TENDER ADDENDUM	ADDENDA À LA SOUMISSION
<p>Sir George-Étienne Cartier Parkway - Rockcliffe Park Lighting Rehabilitation (Phase 4) NCC TENDER FILE # AL1841 September 22, 2022 ADDENDUM # 2</p>	<p>Promenade Sir George-Étienne Cartier - Réhabilitation de l'éclairage du parc Rockcliffe (Phase 4) APPEL D'OFFRE DE LA CCN NO. AL1841 LE 22 septembre 2022 ADDENDA NO. 2</p>

**OPSD 509.010**

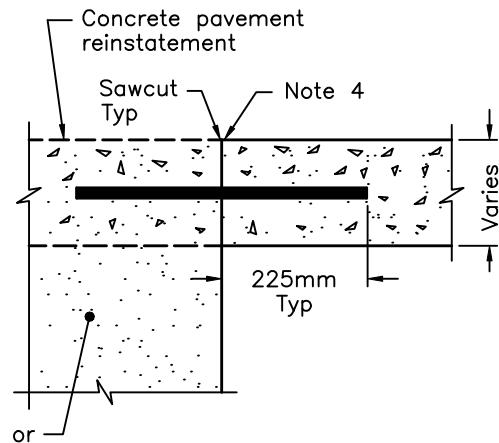
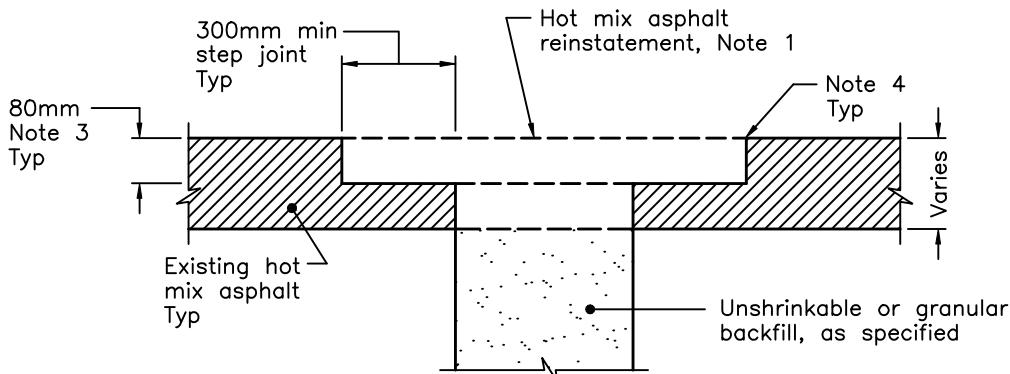
2. Q. I am currently looking at the asphalt reinstatement and a contact has asked me how deep the asphalt is on the road and the sidewalk in order to reinstate it to existing levels. This will be for the saw cutting areas for #10 on illustration E-103 (ADD#1) as well as #3 on the same drawing

Note #10 on Drawing E-103(ADD1)  
Clarification:  
Pavement depth to match existing. The NCC Consultant utilized Ontario Provincial Standard Drawings (OPSD) for roadways throughout in Drawing E-004 and so to maintain consistency Pavement

- Reinternment as per OPSD 509.010 – see annex.
3. Note #3 on Drawing E-103(ADD1)  
Clarification:  
Remove only surface mounted conduit and wire. Do not remove conduit or ducts located under paved areas. Remove wire in conduits or ducts where possible.
- le réinternât de la chaussée selon l'OPSD 509.010 - voir annexe.
3. Note #3 sur le dessin E-103(ADD1)  
Clarification :  
Enlever seulement les conduits et les fils montés en surface. Ne pas enlever les conduits ou les gaines situés sous les zones pavées. Retirer les fils dans les conduits ou les gaines lorsque cela est possible.
